Access Compliance Report

Public Rights-of-Way

(Curb Ramps)

Intersection ID: 10025885	Main Street: ELIZABETH_AV	Cross Street: N/A	Location:	N
ADA ID: E8F6ADB8E610	Ramp Type: Perp	Initial Pass/Fail: Pass	Overall Compliance: No	Severity Score: 2.75
Codes/Mitigation Info/Possible Solution		Field Measurements/Component Compliance

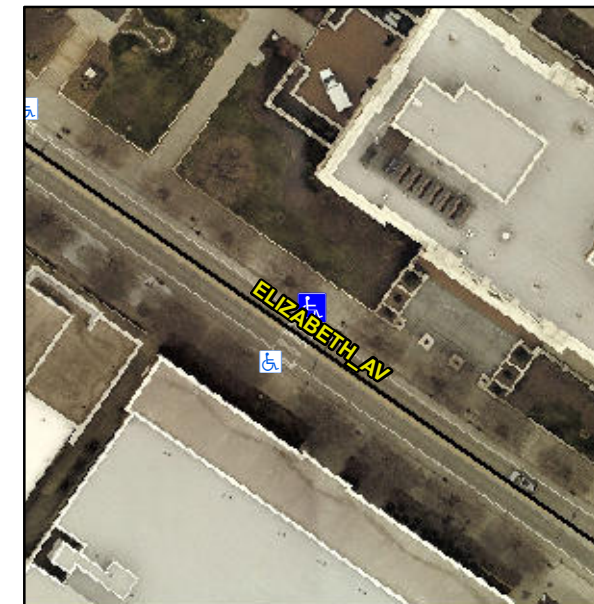
Not Found, R304.2.3, R304.5.3

Compliance	Description	Data	Compliance	Description	Data
N/A	Ramp Length (in)	85.0	Yes	Ramp Slope (%)	5.5
Yes	Ramp Width (in)	96.5	Yes	Ramp XSlope (%)	2.6
N/A	Flare Type LT	Sloped	N/A	Flare Type RT	N/A
N/A	Flare Slope LT (%)	1.1	No	Flare Slope RT (%)	11.8
N/A	Flare Traversable LT?	Yes	N/A	Flare Traversable RT?	Yes
Yes	Landing Length (in)	59.5	Yes	DWS Provided?	Yes
Yes	Landing Width (in)	96.5	Yes	DWS Contrast?	Yes
Yes	Landing Slope (%)	0.5	Yes	DWS Length (in)	24.5
Yes	Landing X Slope (%)	3.1	Yes	DWS Full Width?	Yes
N/A	Landing Curb? (Y/N)	No	Yes	DWS Offset (in)	0.0
N/A	Shared Landing?	No			
Yes	Gutter Ponding?	No	Yes	Gutter Slope (%)	0.5
Yes	Gutter Lip Ht (in)	0.0	No	Gutter X Slope (%)	6.7
N/A	Painted X Walk1?	Yes	N/A	Painted X Walk2?	N/A
	X Walk 1 Direction	To SW		X Walk 2 Direction	N/A
N/A	X Walk 1 Width (in)	151.0	N/A	X Walk 2 Width (in)	N/A
	X Walk 1 Slope (%)	1.0		X Walk 2 Slope (%)	N/A
	X Walk 1 X Slope (%)	3.7		X Walk 2 X Slope (%)	N/A

**Remove & Replace Entire Ramp.
Remove & Replace Gutter.**
